For: TCL Only

Audio Digipot rework

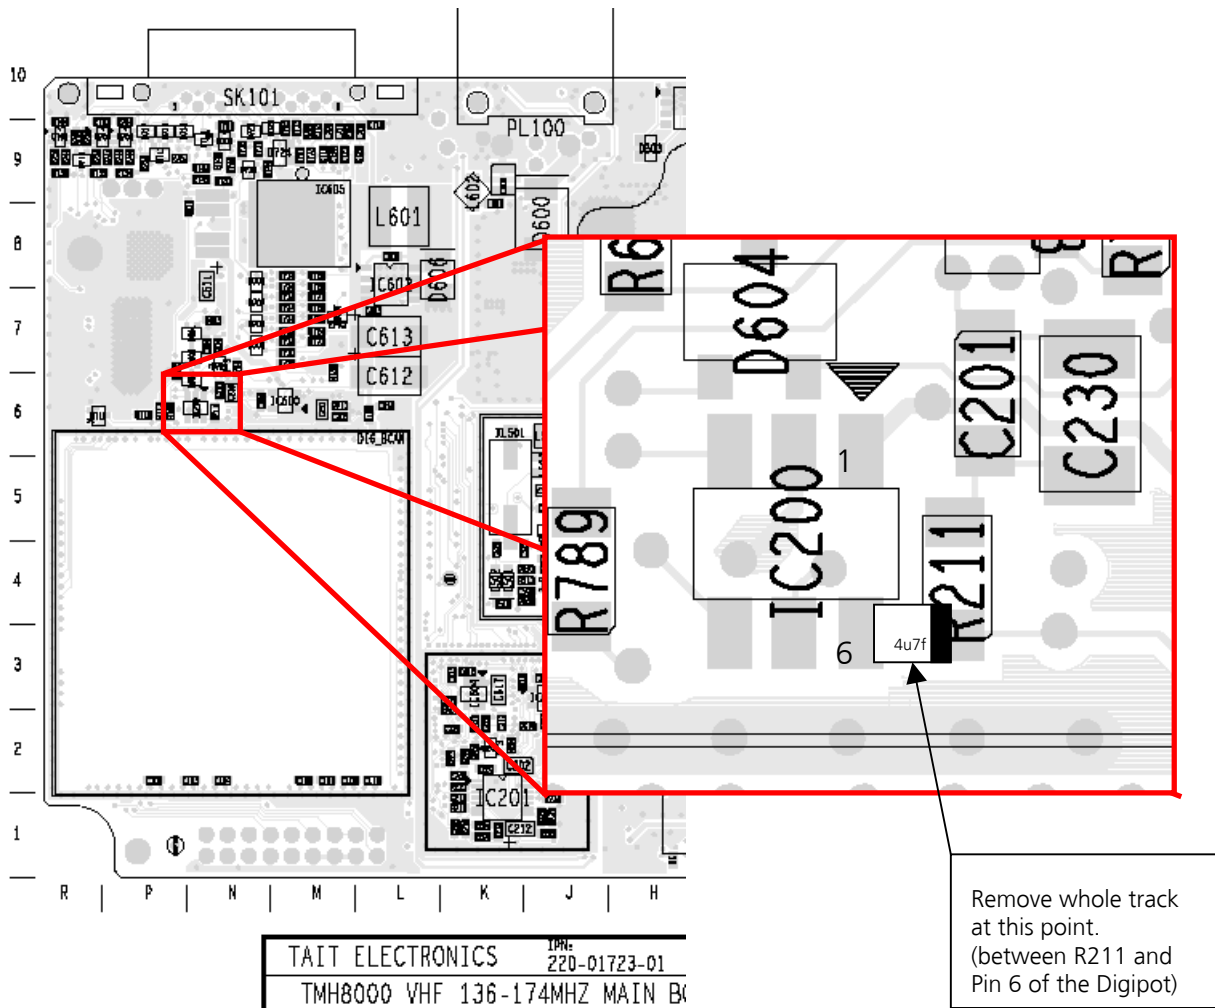
Remove R215: Top of PCB above FPGA can.

Place the 4 μ 7F Tant Cap between pin 6 of IC200 and R211. Positive end of the Tant to R211.
